**City of Richmond**  
Urban Development Division

**Report to Committee**

RZ 04-272331

Re: **Application by Sungrand Development Ltd. for Rezoning at 11651 / 11671 /  
11691 / 11711 Steveston Hwy. from Single-Family Housing District,  
Subdivision Area E (R1/E) to Townhouse District (R2-0.6)**

STEVESTON HWY. Proposed Variance

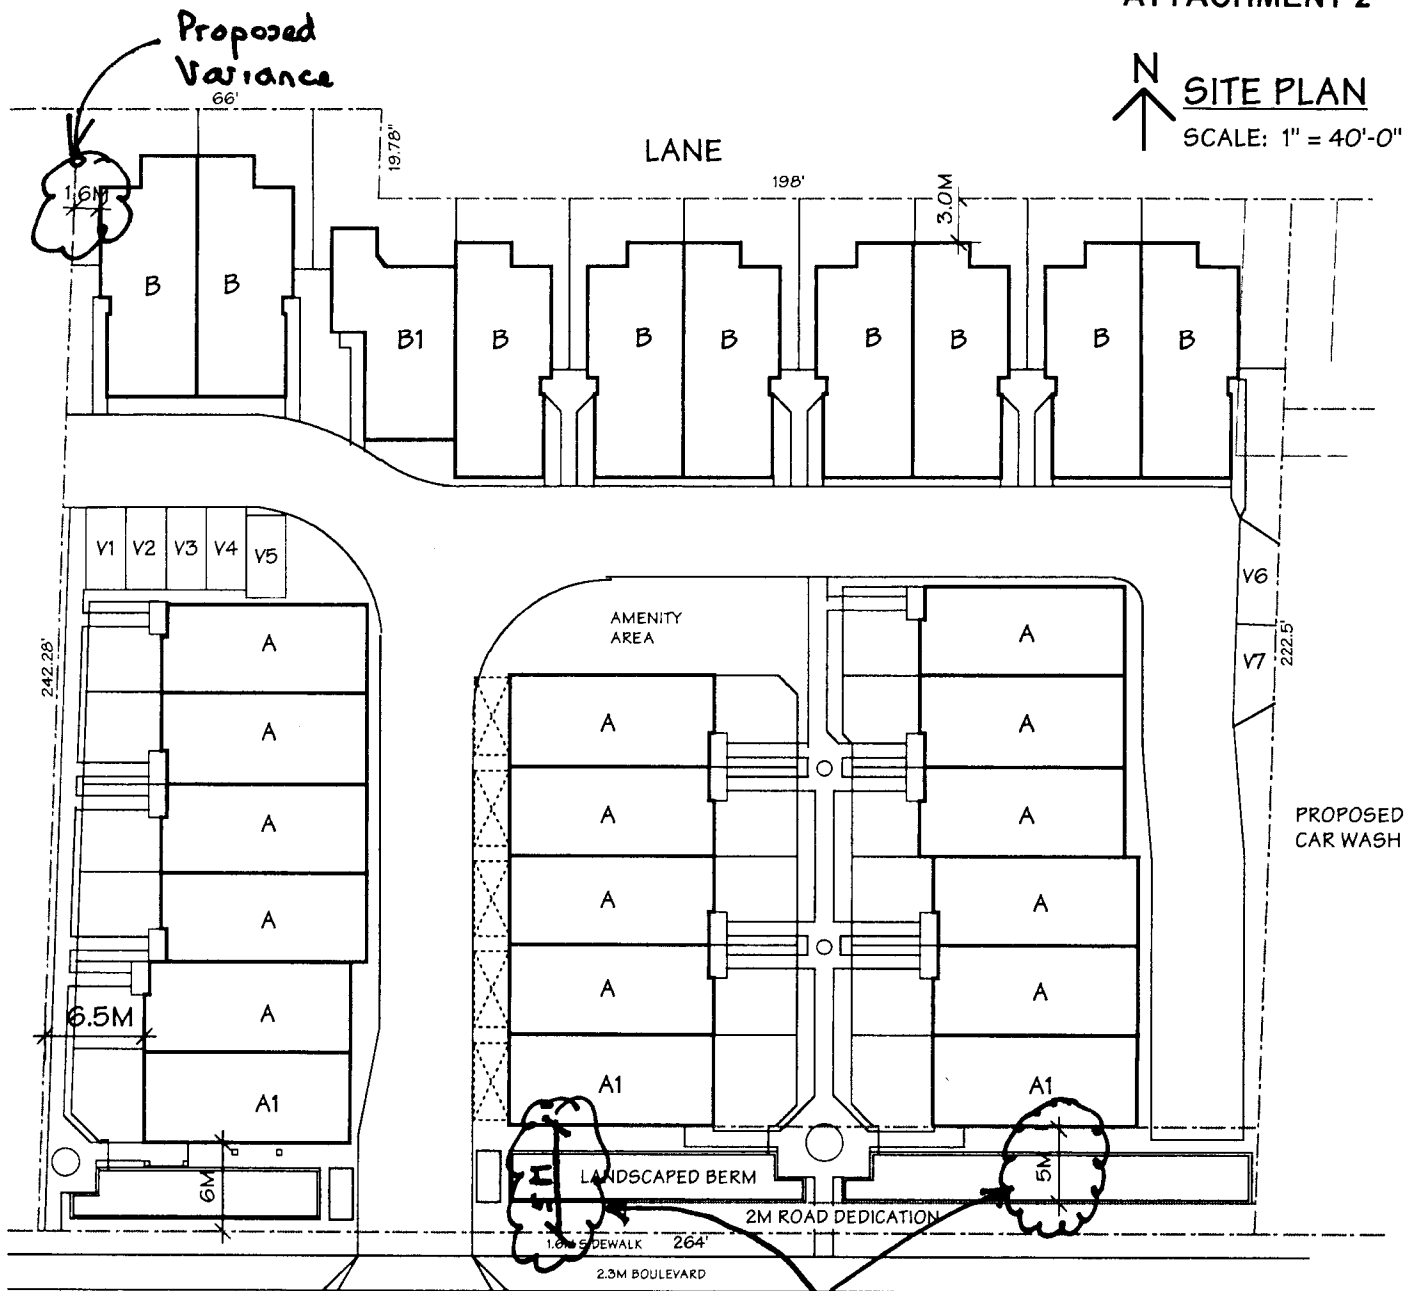
Comments on the site plan dated Sept 14, 2005:

1. Require land dedication of 2-m width along the site's south frontage along Steveston Hwy. from the site's eastern property line to approximately 42 m west of the site's eastern property line.

2. Frontage improvements (including sidewalk, grass-treed Boulevard) are required along the site's Steveston Hwy. frontage.
3. Register on title a 7.5m wide Public Right-Of-Passage (PROP) Right Of Way (ROW) from Steveston Hwy., that tapers at a 5:1 ratio starting at 5m from the site's southern property line along Steveston Hwy, getting down to a 6m PROP at the interior intersection. A 6m wide PROP is also required for the East-West portion of the internal roadway that runs between the interior intersection and the western property line.

4. The entrance driveway is to be 7.5-m wide for a minimum length of 5 m measured from the southern property line into the site. The paved area dimensions should conform to the PROP noted above.

5. Conform to City's Parking Bylaw on the number and dimensions of the off-street parking. Development Permit plans should indicate the parking stall dimensions on a scaled drawing. One handicapped parking stall is required.
6. For the Development Permit, demonstrate how a loading truck (i.e., SU-9) could be accommodated on site. Show vehicle turning paths on a scaled drawing.
7. Prior to issuance of a Building Permit, a construction parking and traffic management plan is to be provided to the Transportation Department to include: location for parking for services, deliveries, workers, loading, application for request for any lane closures (including dates, times, and duration), and proper construction traffic controls as per Traffic Control Manual for Works on Roadways (by Ministry of Transportation) and MMCD Traffic Regulation Section 01570.

There is insufficient info to provide detailed urban design comments. The applicant is advised that the following concerns arise from the site plan and should be addressed in the Development Permit application in addition to design issues:

- Revise site plan to conform to required setbacks and provide required accessible parking space.
- Most of the existing trees are proposed to be removed. All of the perimeter trees and the tree located in the pedestrian street should be considered for retention if viable. To this end, remove V6 as only 6 visitor parking spaces are required.
- There is a missed opportunity to provide back yards for the West units. Careful design will be needed to address CPTED issues and form and character of the proposed narrow pedestrian connection. Consider orienting pedestrian front entries to much more visible and prominent manoeuvring aisle.
- Improve views into and within development.
- Locations and details are required for recycling, garbage, mailbox and servicing closets/rooms.
